# UNITED STATES PATENT AND TRADEMARK OFFICE

APPLICATION NO.	FILING DATE	FIRST NAMED INVENTOR	ATTORNEY DOCKET NO.	CONFIRMATION NO.
10/826,056	04/16/2004	M. Saif Islam	200312090-1	9464

## Office Action Summary

## DETAILED ACTION

**Fig. 15**

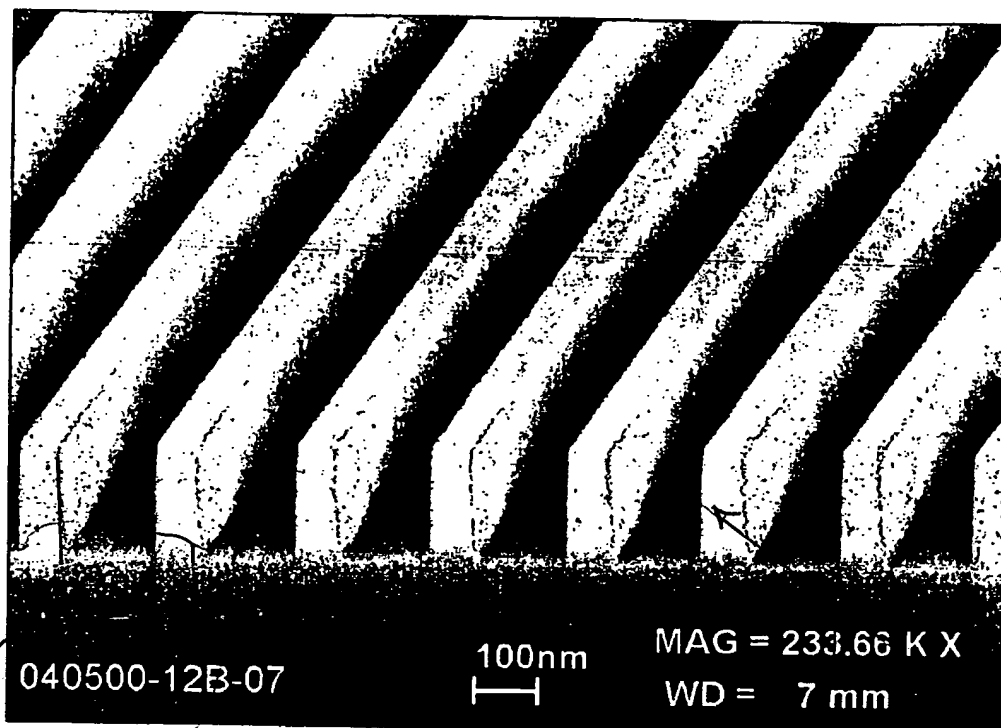
Chou et al (figs 13-17's, text [0001]-[0099]) discloses the claimed imprinting apparatus comprising: a semiconductor substrate (NIL mold 20A, fig 13C or 15, text paragraph [0074]) having a (110) direction planar surface, the semiconductor substrate having a trench (see fig 15 as attachment: trench defined by the vertical sidewalls noticed in figure) with vertical sidewalls, the vertical sidewalls being aligned with (111) vertical lattice planes of the semiconductor substrate; a plurality of vertical structures disposed in the trench between the vertical sidewalls (see fig 15 as attachment); and alternating layers of a first material and a second material in the trench, the second material layers having portions that extend vertically, the vertically extending portions being the plurality of the vertical structures, wherein the vertical structures are spaced apart from each other and from the vertical sidewalls of the trench to form a mold that provide a pattern for imprinting, wherein one layer of the first material is adjacent to the semiconductor substrate in trench, a thickness of the first material layer defines spaces between the vertical structures and further defines spaces between the vertical sidewall of the trench and a vertical structure of the plurality of the vertical structure that is adjacent to the vertical sidewall of the trench, wherein the alternating layers define an internal depth of the imprinting apparatus (see fig 15 as attachment for details).
